NORTH SYDNEY COUNCIL REPORTS

NSLPP MEETING HELD ON 01/02/2023 SECTION 4.55 APPLICATION REPORT

ADDRESS/WARD: 34 Grosvenor Street, Neutral Bay

APPLICATION No: DA 237/20/7

Figures 1 – 3: Proposed Modifications

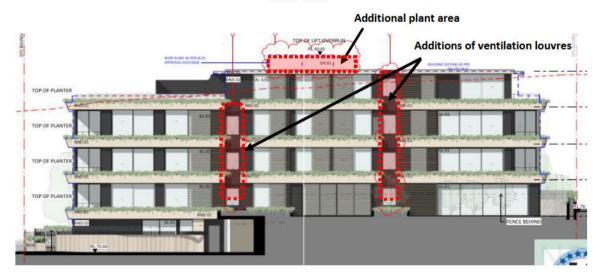
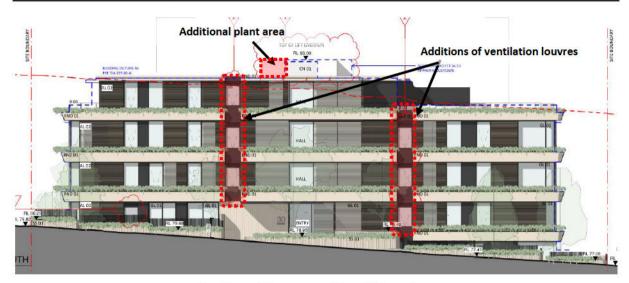
(a) Roof Level (RL91.55):

An extension of the rooftop plant area to accommodate air conditioning units and a compliant hot water plant storage tank.

(b) Ventilation Louvres

Modifications to kitchen and hallway windows on Ground Level, Levels 1 to 3 on the northern and southern elevations to incorporate ventilation louvres.

Figure 7: Proposed Development and the LEP Maximum Building Height

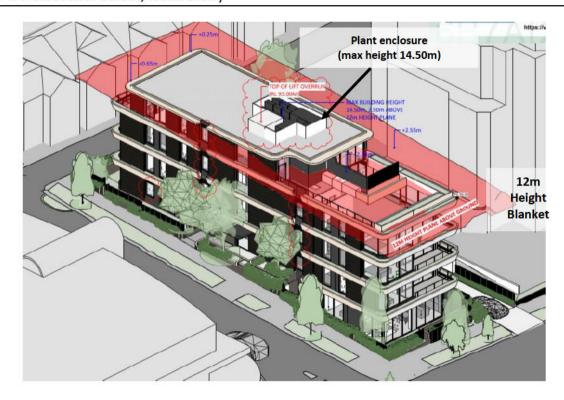
The maximum building height breach would be 2.50m for the top north-eastern corner of the lift overrun. The previously approved and the proposed non-complying building elements are shown above the 12m building height blanket in **Figure 7** below.

It is considered that the proposed modifications would have no material impacts on significant views as seen from the public domain and the surrounding properties because the location of the modified structures would have an easterly location away from the significant views on the western side of the subject site as seen from the adjoining residential properties to the south and west.

Furthermore, the modified structures would be located away from the adjoining properties to the south resulting in no material shadowing impacts.

(1)(d) To maintain privacy for residents of existing dwelling and to promote privacy for residents of new buildings — The proposed rooftop plant area extension is unlikely to cause noise nuisance for the adjoining properties given the minimum separation of 17m between the proposed enclosure and the nearest building to the north. Furthermore, a condition is recommended requiring an acoustic review of the plant area to ensure the amenity of the surrounding properties (Condition C46).

There are sufficient environmental planning grounds to justify the modifications, as amended by conditions of consent, to the variation to the building height control.

Screens for Rooftop Plant Area

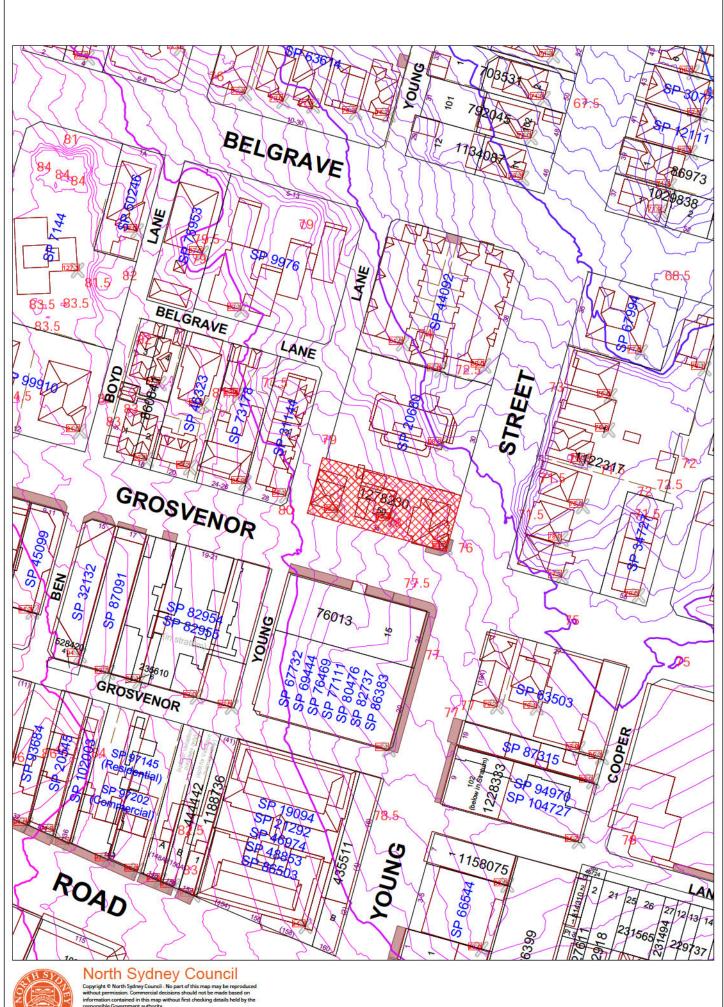
Concerns about the appearance of the roof plant area as seen from a high-rise apartment building to the north.

As indicated earlier in this report, the applicant has provided design details for the proposed screens for the rooftop plant area. The 1.45m high aluminum screen would be installed along the perimeter of the rooftop plant area and would match the height of the adjacent lift overrun at RL93.00. The screens would have a powder coated finish with a light grey colour to match the appearance of the lift overrun.

C47. The design details and materials for the screens to be installed along the perimeter of the rooftop plant area must be consistent with the details as contained in drawing numbered A4302 Rev 1, dated 7 November 2022 and prepared by Team 2 Architects. The colour of the screens shall match the light grey colour to be applied to the lift overrun adjacent to the rooftop plant area.
